MARY RIVER PROJECT

4.0 MILNE INLET

MILNE INLET PHOTOS

Sediment Pond East

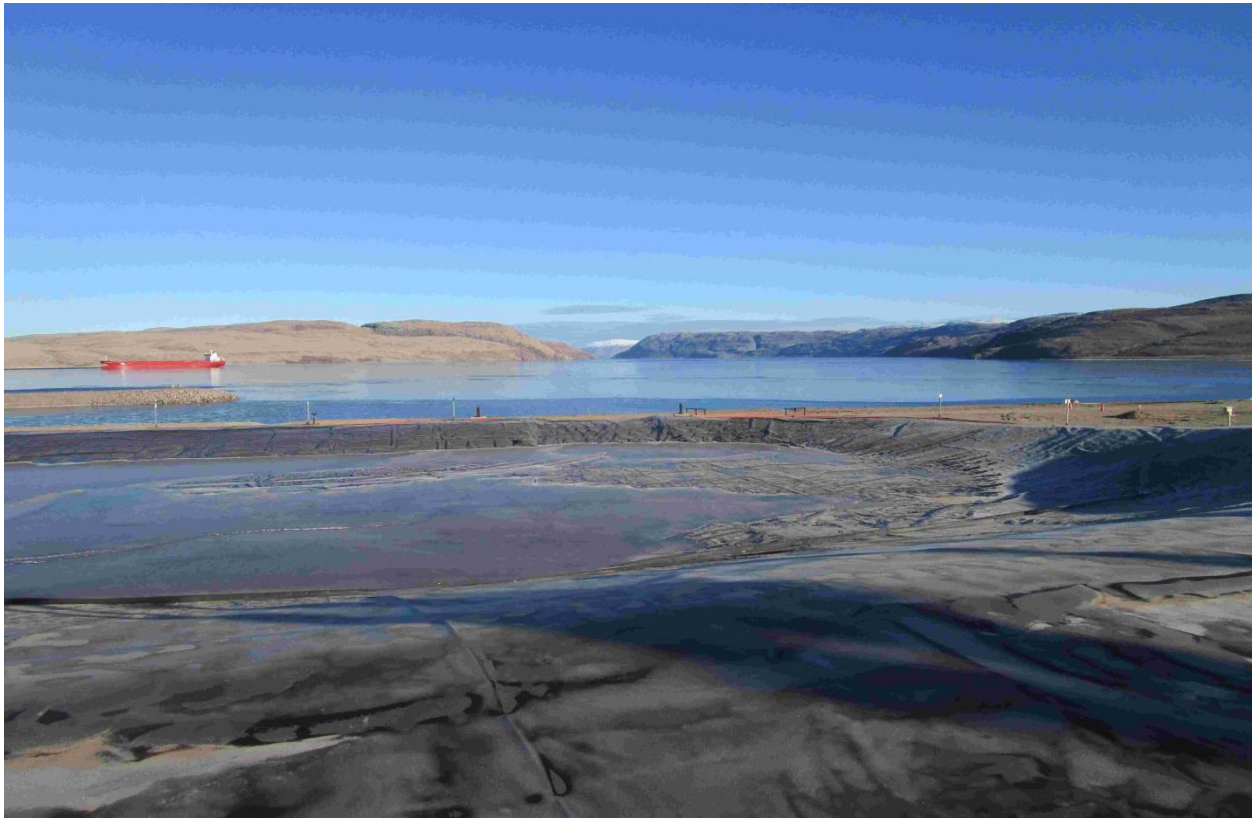
We have concerns over the stability of the liner and recommend more soil ballast on the south edge and possibly tire ballast over the liner which appears subject to wind damage. This shall provide a function for used tires.

A review of the south edge of the liner shows very minor movement in the liner at the south edge probably due to wind uplift of the liner. This was forecast in our July/August report.

We recommend review of the use of a ballast (possibly tires) on the exposed liner at the dyke to prevent wind uplift.

Steel Fuel Tank Containment

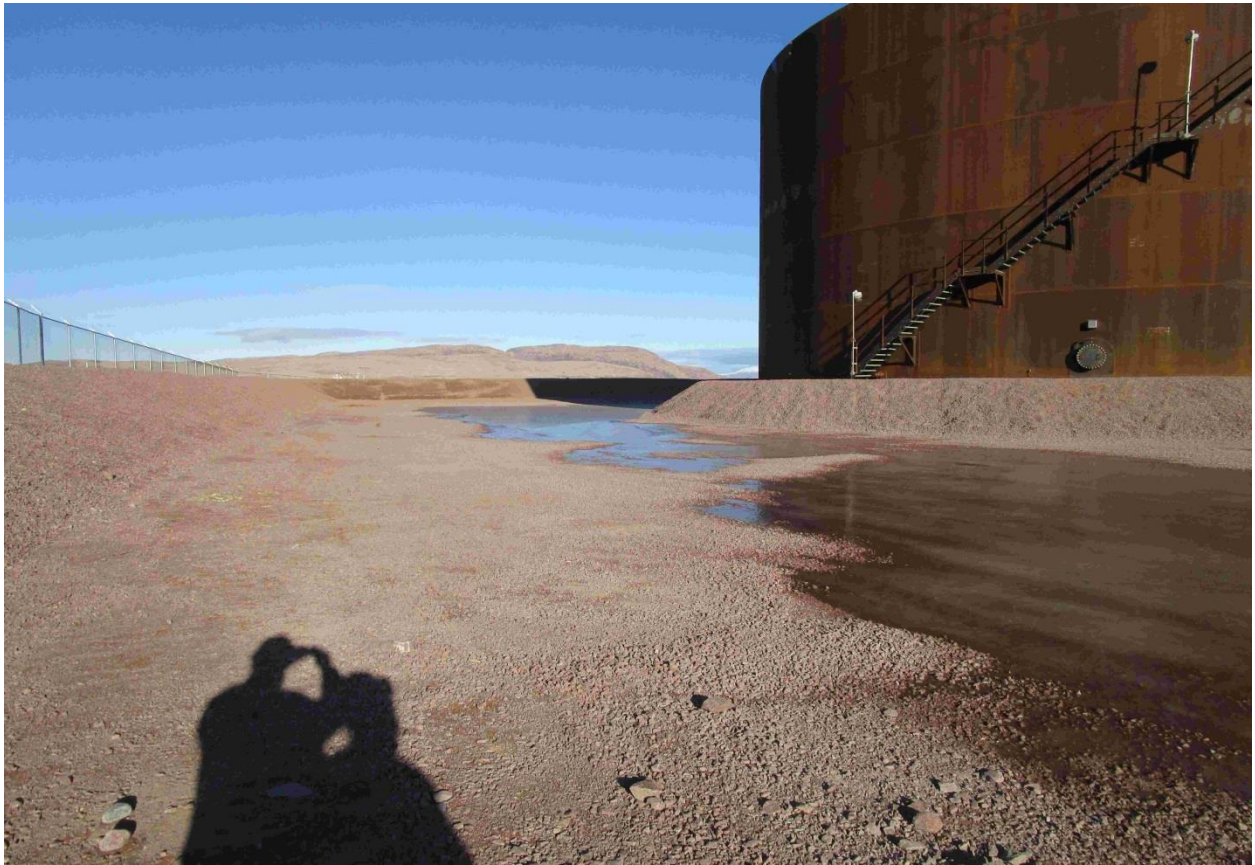
We note that the sump placed in the containment is located at the high end of the containment. There is water ponding in the low end of the containment. Water has been pumped from the low end of the containment since our review in July/August and there is considerably less water in the containment

We recommend that a sump be considered at the low point at the north end of the containment, to better facilitate the removal of water to minimize the treatment of water should a minor spill occur within the containment.
